Subject: Elevator Linkage at the base of the stick

Affected: Glider-Model BS-1
All Works Nos.

Reason: Failure of 2 Linkages

301-41-3/2a

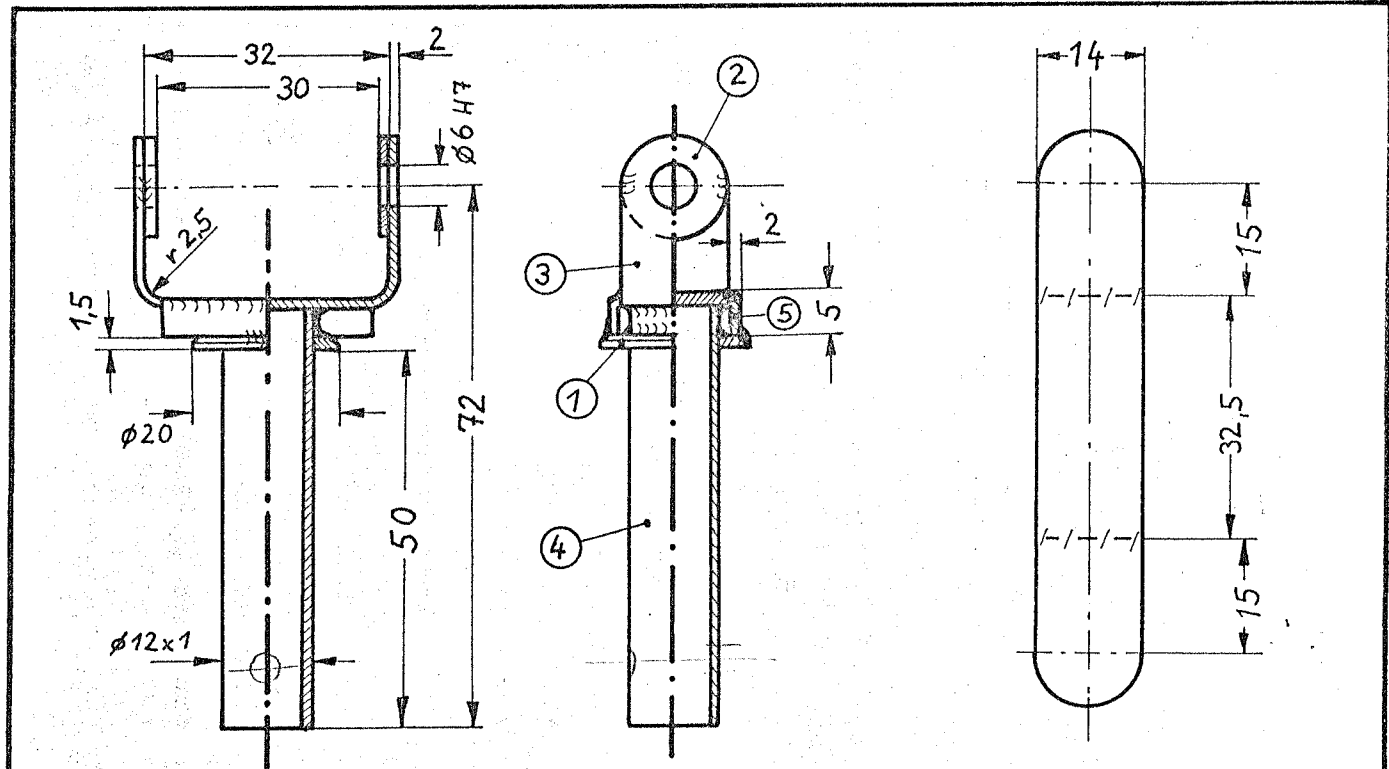
Action 1: The Elevator Linkage at the base of the stick (see modified drawing No. 301-41-3/2a) must be inspected carefully for possible cracks near the welded seam.
This inspection must be made immediately and again following the application of high loads to the glider (e.g. hard landings or ground loops).
If cracks are found the glider must not be flown until the defective part has been replaced.

Action 2: The Elevator Linkage at the base of the stick must be replaced by a modified part in accordance with drawing No. 301-41-3/2a.
Replacement must in all cases be effected before next periodical inspection.

Wärmebehandlung:
Anlassen in Schutzgas
1 Std. bei 550°C
